MARS HILL ROAD
TRACT
LAND LOT 186 & 195, 20TH DISTRICT, 2ND SECTION,
COBB COUNTY, GEORGIA

PETITION NO: Z-1

ZONING COMMENTS:

PROJECT NO.	FIELD BOOK
DRAWN BY	DPH
CHECKED BY	
DATE	1/9/14
SHEET NUMBER	01

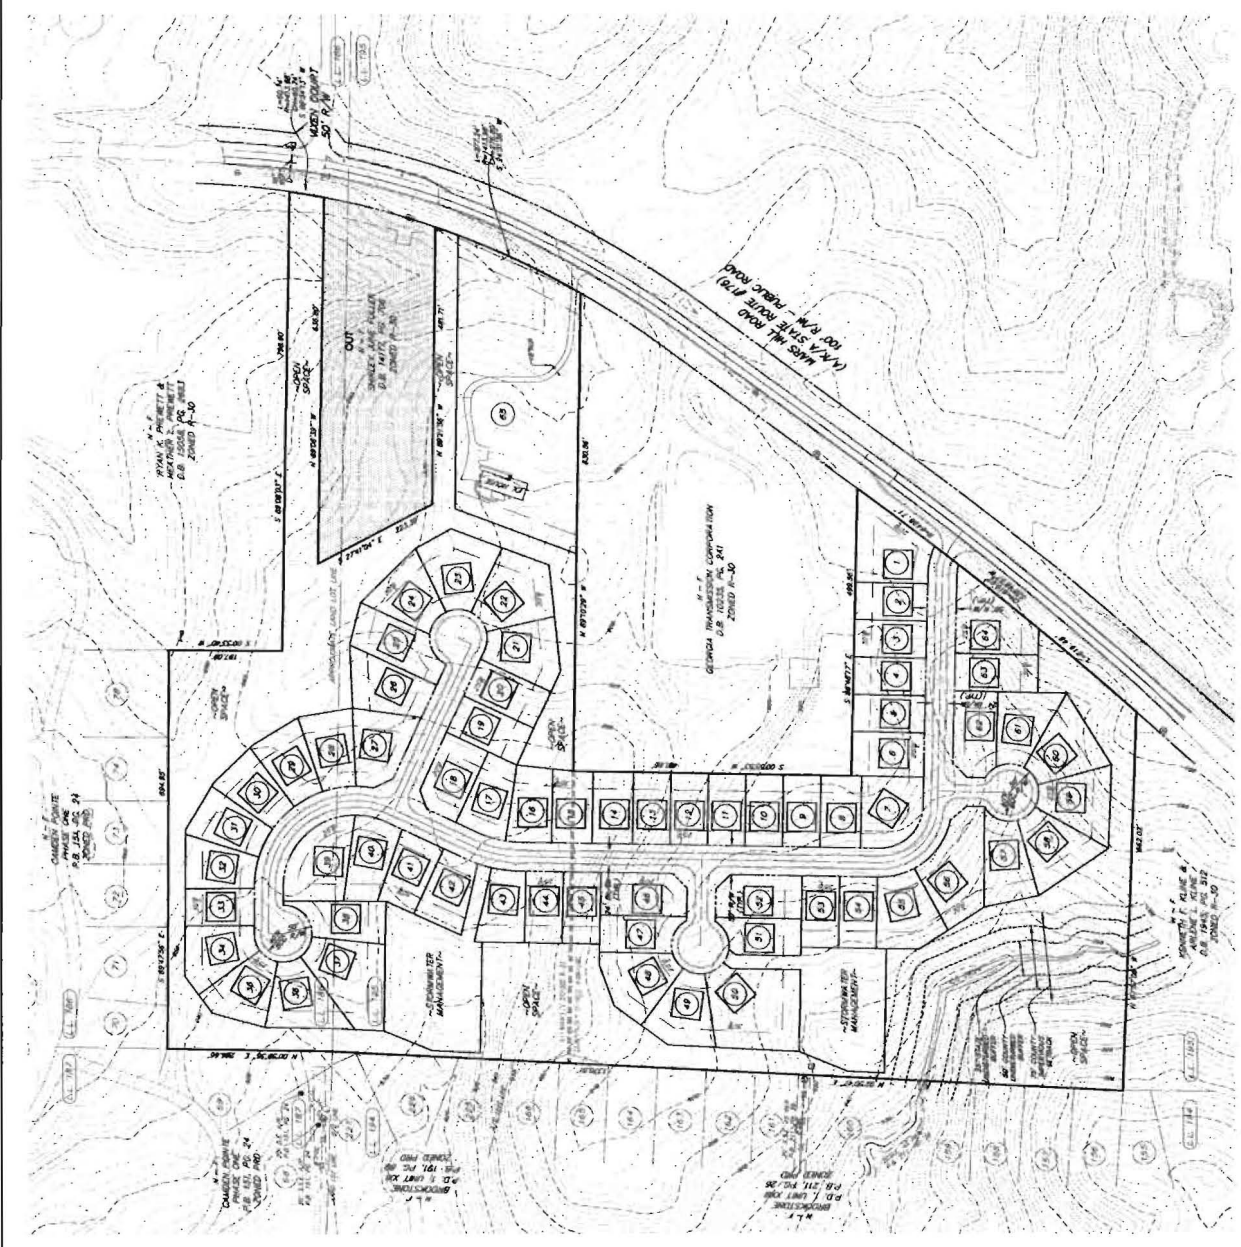
1. Current density exceeds future land use guidelines. Please provide plan with density that is consistent with the VLDR range (1 to 2 upa).
2. Provide pedestrian easement(s) of at least 15 feet wide to allow access of commonly owned open space.

1. A drainage easement will be required at the rear of lots 37-39 to limit offsite runoff bypass.
2. Elevated erosion control measures including a mulch berm along the rear of lots 24-26 will be required to protect the downstream lake within Camden Pointe Subdivision.
